**Natural Resources Canada - Information Request
Responses - Gahcho Kué Project Environmental Impact Review**

GAHCHO KUÉ PROJECT ENVIRONMENTAL IMPACT STATEMENT
INFORMATION REQUEST RESPONSES

Information Request Number: NRCan 1-1

Figure NRCan_1-7-1 Classification of Material pH Values (from Environment Canada [2012])

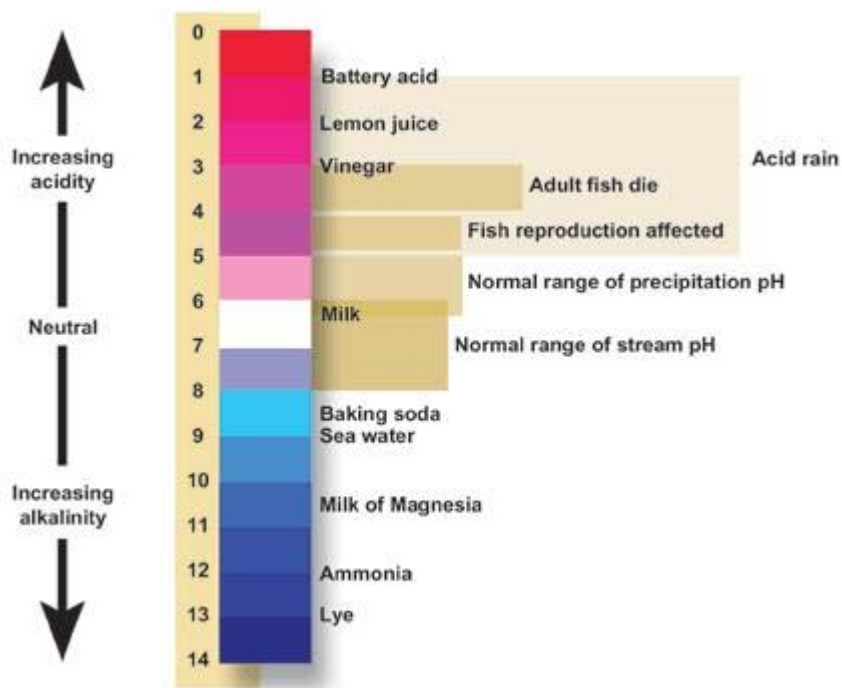
- (i) Please indicate the methodology referring to the pH value and reference of the results.
- (ii) Please provide the definition of a neutral pH or reconsider wording in the document.

- (i) The method used to determine the pH value of the mine rock is based on the method for paste pH described in Price (1997) and Sobek et al. (1978), referenced in the Acid Base Accounting section of Appendix 8.II, Attachment 8.II.2 of the 2010 EIS (De Beers 2010). The method involves the use of 20 grams (g) of dried rock material crushed to less than 0.1 millimetre (mm). The material is mixed with 20 millilitres (mL) of distilled water and allowed to stand for 10 minutes before the pH is measured. The purpose of the method is to determine whether the material is acidic, neutral or alkaline.
- (ii) The use of the term "neutral" in the context of the EIS 2010 with respect to pH was used to differentiate waters that were within a naturally occurring range of conditions that would not be considered indicative of anthropogenic derived acidity, or acid rock drainage (ARD) derived acidity.

The pH range of natural waters as shown in Figure NRCan_1-7-1, sourced from Environment Canada (2012). This figure illustrates typical pH values of

environmental water sources, including normal precipitation, normal stream water and acid rain. Normal precipitation is classified as precipitation reporting a pH value higher than 5.3 whereas Environment Canada considers rainwater values below pH 5.3 as acid rain.
